Transgrid Reference Number: 2024-262

DA / CNR Number: DA24/0294 | CNR-68778

Location: 221-227 Luddenham Road, Orchard Hills NSW 2748

Proposal: Updated stormwater irrigation/distribution system in the easement

Figure 1: Traffic controllers siting and locations for construction management

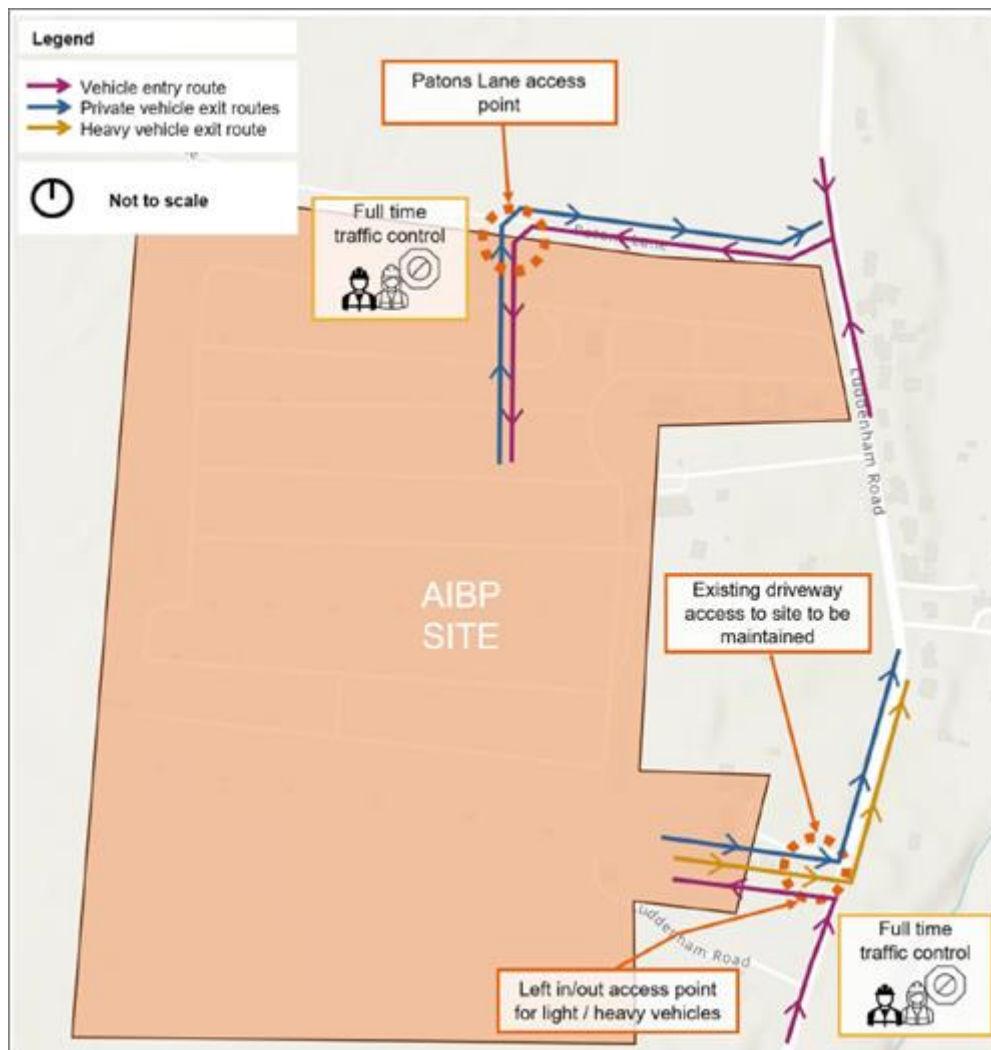
Accordingly, as shown in Figure 1 below the traffic controllers proposed to be located at the Patons Lane site access and Luddenham Road southern access (refer to the figure below) may not have visibility of vehicle queuing on Patons Lane/ Luddenham Road intersection resulting in effective traffic management of vehicles entering and exiting the site. Recommendations to manage this issue should be addressed in the CTMP in consultation with Sydney Metro (refer to recommendations section of this letter).

- Prior to the issue of any construction certificate the applicant shall prepare a CTMP in consultation and to the satisfaction of Transport for NSW and Sydney Metro. The CTMP will need to incorporate the following considerations:
 - The updated traffic surveys and intersection assessment at Patons Lane and Luddenham Road.
 - Vehicular traffic generated during the construction stage shall not be permitted to enter and exit via Patons Lane and Luddenham Road intersection during the Sydney Metro's peak construction hours, which are between 7:30am and 8:30am, and 4:30pm and 5:30pm weekdays. The Applicant to consider using the AIBP site's southern access point for access and egress of all light and heavy vehicles during peak periods.

- For periods outside of the construction peak hours, reverting to the one-way loop arrangement, that is, enter via Patons Lane and exit via southern access off Luddenham Road. Alternatively, a traffic controller be engaged by the application to be positioned at Patons Lane and Luddenham Road intersection to monitor and manage vehicles queuing, which will enable the construction vehicles to enter and exit via Patons Lane during the off-peak construction periods.

- Traffic controllers are to ensure that Sydney Metro construction traffic be given priority access to Patons Lane to minimise disruptions for Sydney Metro's construction activities and deliveries, and if required, traffic controllers must divert any Alspeck Industrial Business Park (AIBP) construction vehicles to access the site via the existing driveway on Luddenham Road.
